Internal Ref: EXTERNAL/2024/0006

**Inner West Council Response: SSD-68298726 – Rozelle Village, mixed use development with affordable housing.**

Property: 138-152 and 154-156 Victoria Road; 697 Darling, 699 Darling Street and 1 Waterloo Street, 3 to 7 Waterloo Street, ROZELLE NSW 2039

**Figure 13:** Building envelopes – illustrates the maximum development envelopes (Source: *Leichhardt DCP – Part D1*)

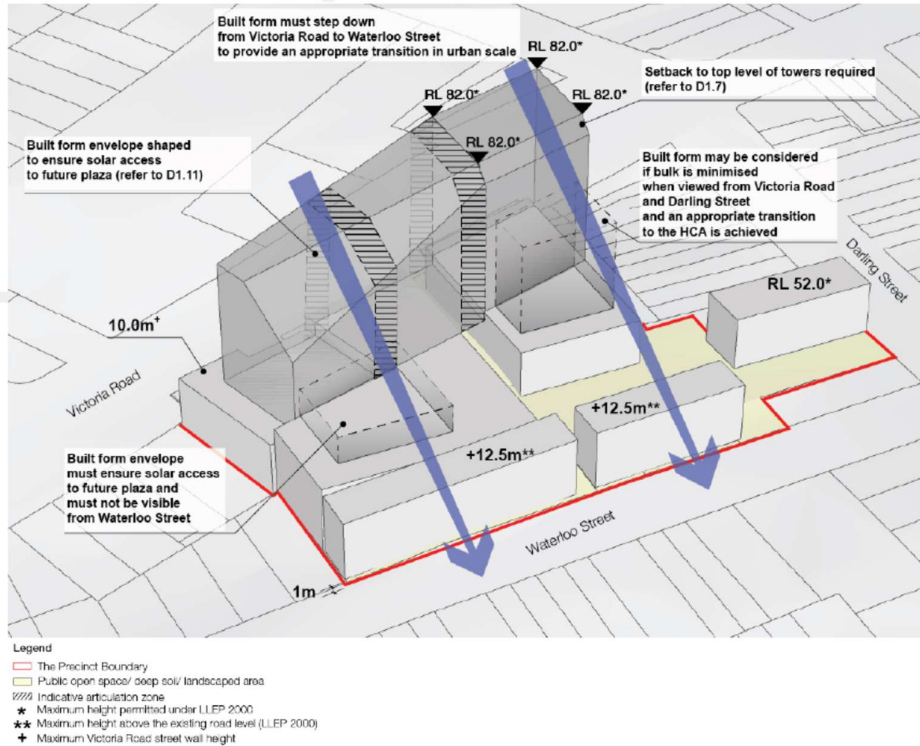
Section	Provisions	Compliance
	<ul style="list-style-type: none"> <li>• C4. Provide a higher built form fronting Victoria Road and a low scale built form along Waterloo Street and Darling Street to reflect the existing low scale and fine grain character of the streetscapes.</li> <li>• C5. Lower podium level buildings are to be placed around the perimeter of the Precinct to form a street edge.</li> <li>• C6. The tower built form along Victoria Road is to step down from southeast (highest) to northwest (lowest) to provide a height transition to the low scale properties to the northwest of the Precinct and protect solar access to the proposed plaza at the centre of the Precinct. Refer to Figure 5.</li> <li>• C7. A two storey (10m maximum height) street wall is to be provided along Victoria Road which is to be defined by appropriate architectural treatments and materials. Building forms (i.e. towers) above the street wall height shall be setback from the line of the building below a minimum of 3m.</li> <li>• C8. Provide effective built form and façade articulation to break up the overall podium and tower building envelopes along Victoria Road.</li> <li>• C9. The building forms along Waterloo Street should be vertically articulated to reflect the pattern of residential lot development and step with the topography. Design the Waterloo Street frontage as a transition between the existing residential streetscape and the new mixed-use development.</li> <li>• C10. Development within the HCA shall be restricted to a maximum height of RL 52.0 AHD and be consistent with adjoining properties with respect to height and scale.</li> <li>• C11. The maximum floor space ratio may not necessarily be able to be achieved if adverse visual, acoustic, privacy, amenity and overshadowing impacts occur to neighbouring properties and/or impact the development within the Precinct.</li> <li>• C12. The building envelopes in Figure 5 define the preferred built form outcome for the Precinct, whilst permitting architectural innovation within the building envelopes.</li> <li>• C13. The building envelopes illustrated in this section allow for some flexibility in the detailed architectural design of buildings. This development control is intended to promote highly articulated buildings with generous balconies, recesses, and steps in facades to avoid a sense of excessive bulk, especially along Victoria Road and when viewed from Darling and Waterloo Streets.</li> <li>• C14. Alternative building envelopes will only be permitted if the proposal can demonstrate a higher quality outcome can be achieved with regard to:             <ul style="list-style-type: none"> <li>- response to the surrounding context</li> <li>- built form and scale transition across the Precinct</li> <li>- impacts to the HCA and heritage items</li> </ul> </li> </ul>

Section	Provisions	Compliance
	<ul style="list-style-type: none"> <li>- amenity to the surrounding properties and within the Precinct</li> <li>- amenity to the future plaza</li> <li>- the Precinct's permeability and connectivity</li> </ul>
